NUMBER: 18-094-15

SUBJECT:

Flash: 3.0L Powertrain Diagnostic and System Improvements

2014 (WK) Jeep Grand Cherokee

Fig. 1 EGT Sensor Bank 1 Sensor 1

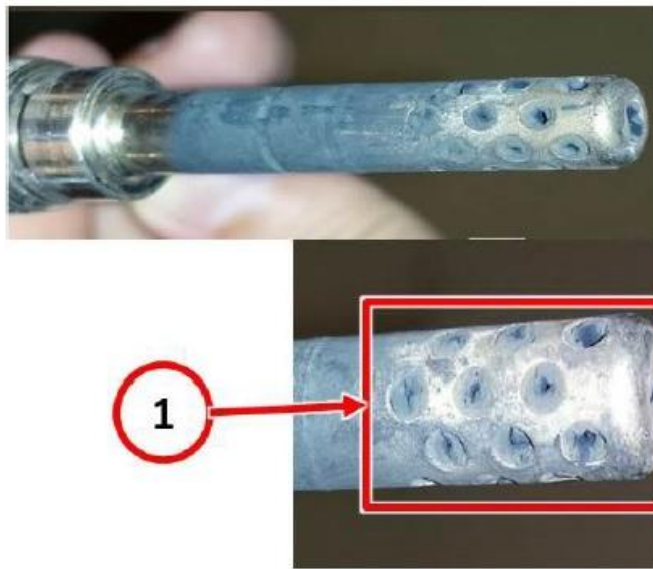
10. Remove the EGT Sensor 1/2 located in the inlet of the Diesel Particulate Filter (DPF)/Diesel Oxidation Catalyst (DOC) assembly. Refer to detailed removal procedures available in DealerCONNECT> TechCONNECT> Service Info Section 11 - Exhaust System> Sensor, Exhaust Temperature> Removal> Exhaust Gas Temperature Sensor 1/2.
11. Remove the Catalyst Temperature Sensor located in the middle of the Diesel Particulate Filter (DPF)/Diesel Oxidation Catalyst (DOC) assembly. Refer to detailed removal procedures available in DealerCONNECT> TechCONNECT> Service Info Section 11 - Exhaust System> Sensor, Exhaust Temperature> Removal> Catalyst Exhaust Temperature Sensor.
12. Inspect the sensor body and probe for any signs of damage or excessive soot. See (Fig. 1).

1 - Excessive soot blocking sensor ports

-
13. Was excessive soot found on the sensor?
 - a. Yes>>> Proceed to [Step #14](#).
 - b. No>>> Proceed to [Step #15](#).
 14. Using shop air set to a maximum of 80 psi, clean all excessive soot from the sensor probe.
 15. Using a suitable multi-meter with appropriate test probes, test the resistance between the sensor connector terminals 1 and 2. With the sensor at room temperature, 65-75 °F (18-25 °C), the resistance should measure between 200 and 240 ohms.
 16. Is the temperature sensor resistance within specifications?
 - a. Yes>>> Install the original EGT sensor 1/2 and/or Catalyst Temperature Sensor. Refer to detailed installation procedures available in DealerCONNECT> TechCONNECT> Service Info Section 11 - Exhaust System> Sensor, Exhaust Temperature> Installation> Exhaust Gas Temperature Sensor 1/2.
